MEMORANDUM FOR: Darrell G. Eisenhut, Director, Division of Licensing, NRR  
 FROM: Roger J. Mattson, Director, Division of Systems Integration, NRR  
 SUBJECT: FIRE PROTECTION RULE - APPENDIX R *Clarification of*

ATTACHMENT 1  
CLARIFICATION OF GENERIC LETTER

### REWRITE OF SECTION 8 REQUEST FOR ADDITIONAL INFORMATION

Diagram 2A

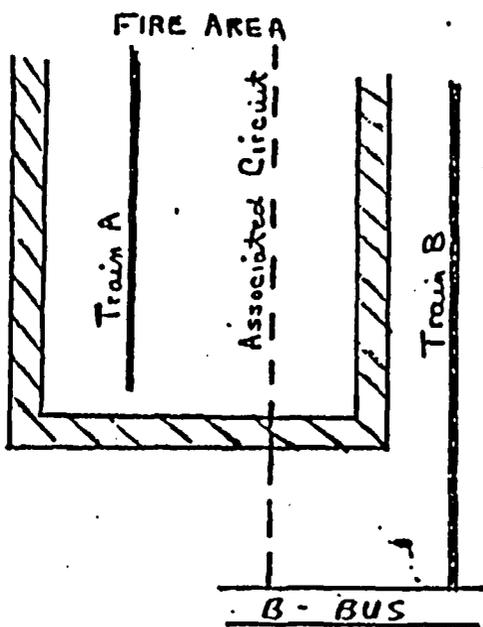
1. Have a physical separation less than that required by Section III.G.2 of Appendix R, and;
2. Have one of the following:
  - a. a common power source with the shutdown equipment (redundant or alternative) and the power source is not electrically protected from the circuit of concern by coordinated breakers, fuses, or similar devices (see diagram 2a), or

2. a. For a common power source case of associated circuit:

Provide load fuse/breaker (interrupting devices) to feeder fuse/breaker coordination to prevent loss of the redundant or alternative shutdown power source. To ensure that the following coordination criteria are met the following should apply:

Diagram 2B

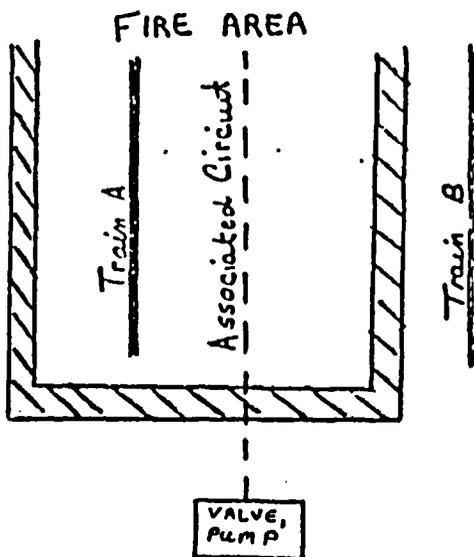
- b. a connection to circuits of equipment whose spurious operation would adversely affect the shutdown capability (e.g., RHR/RCS isolation valves, ADS valves, PORVs, steam generator atmospheric dump valves, instrumentation, steam bypass, etc.) (see diagram 2b), or

- b. For circuits of equipment and/or components whose spurious operation would affect the capability to safely shutdown:

- (1) provide a means to isolate the equipment and/or components from the fire area prior to the fire (i.e., remove power cables, open circuit breakers); or
- (2) provide electrical isolation that prevents spurious operation. Potential isolation devices include breakers, fuses, amplifiers, control switches, current XFRS, fiber optic couplers, relays and transducers; or
- (3) provide a means to detect spurious operations and then procedures to defeat the maloperation of equipment (i.e., closure of the block valve if PORV spuriously operates, opening of the breakers to remove spurious operation of safety injection);

Diagram 2C

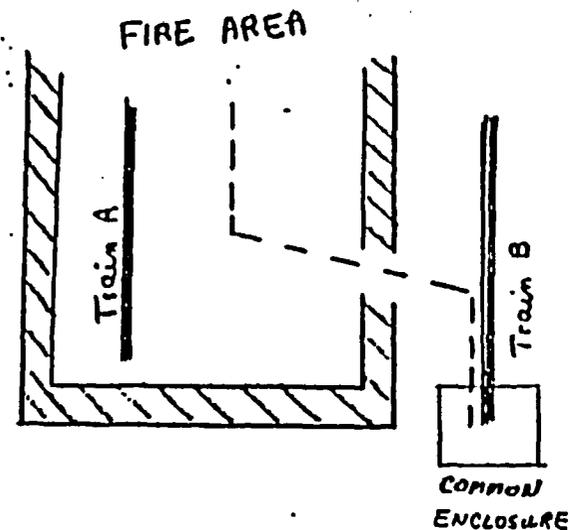
- c. a common enclosure (e.g., raceway, panel, junction) with the shutdown cables (redundant and alternative) and,
    - (1) are not electrically protected by circuit breakers, fuses or similar devices, or

- (2) will allow propagation of the fire into the common enclosure, (see diagram 2c).

c. For common enclosure cases of associated circuits:

- (1) provide appropriate measures to prevent propagation of the fire; and
- (2) provide electrical protection (i.e., breakers, fuses or similar devices)
